DRAFT
SAFETY EVALUATION REPORT

Docket No. 72-1027
TN-68 Dry Storage Cask
Certificate of Compliance No. 1027
Amendment No. 1

Docket No. 72-1027
TN-68 Dry Storage Cask
Certificate of Compliance No. 1027
Amendment No. 1

Figure 1 – Example TN-68 Cask Storage Configuration (Based on SAR Figure 4.10-1)

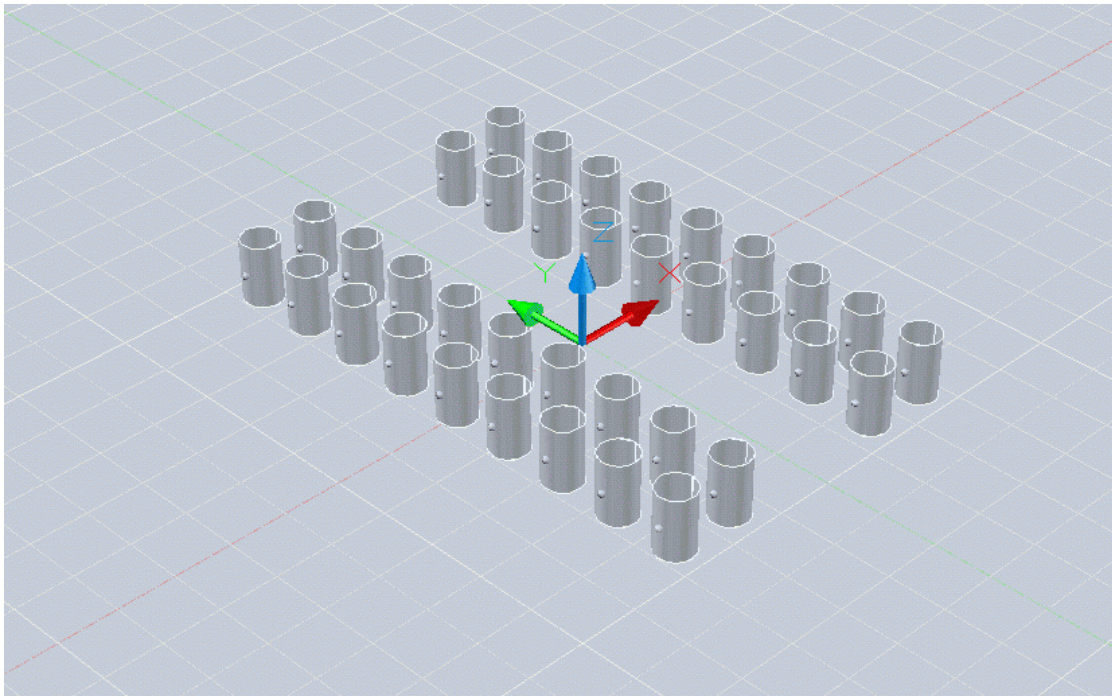
The staff reviewed the applicant's approach for determining the view factor for radiative exchange from the cask surface to the environment (which used an engineering textbook correlation rather than an actual calculation) and determined that it was a non-conservative approach.

To more precisely evaluate the level of conservatism in the results obtained with the proposed methodology, the staff constructed a view factor computation model for a fully loaded TN-68 cask in a typical storage array (as illustrated in Figure 4.10-1 of 72-1027 TN-68 Amendment 1 SAR, Rev. 0, 01/05). This model was developed using RadCad® v5.0, which determines view factors between specified geometric shapes by means of ray-tracing. A graphical representation of the RadCad® v5.0 model is shown in Figure 1 below.

The staff determined that the view factor of the emitting cask in Figure 1 to the environment, with the concrete storage pads and access road conservatively considered to have no communication with the cask surface, was approximately 0.33. The applicant's original value of 0.62 for the view factor was considered to be non-conservative.

The staff requested that the applicant submit a calculation of the view factor in order to more appropriately capture the actual behavior of radiative exchange between a cask in an array of casks situated on a storage pad. The applicant submitted a view factor calculation that utilized the radiosity method of the ANSYS FEA code, and completed a sensitivity study of the effect of variations of the view factor on the thermal performance of the cask. The applicant documented this effort in Sections 4.10.1.1 and 4.10.1.3 of the SAR.

The staff reviewed the ANSYS model that was submitted by the applicant and found some minor errors related to the mirror plane and the resolution of the view factor calculation in the submitted model. The staff discussed the issues with the applicant, and, by letter dated March 16, 2007, the applicant provided a revised model that the staff found acceptable.

The applicant should use the modeling approach accepted by the staff for any future calculations related to the exchange of radiation between the cask and the surrounding environment for the TN-68 cask design. The applicant must consider the geometry of the cask storage pad when evaluating site specific application of the TN-68 cask design at a storage facility, since their view factor calculation method is dependent on the pad geometry.
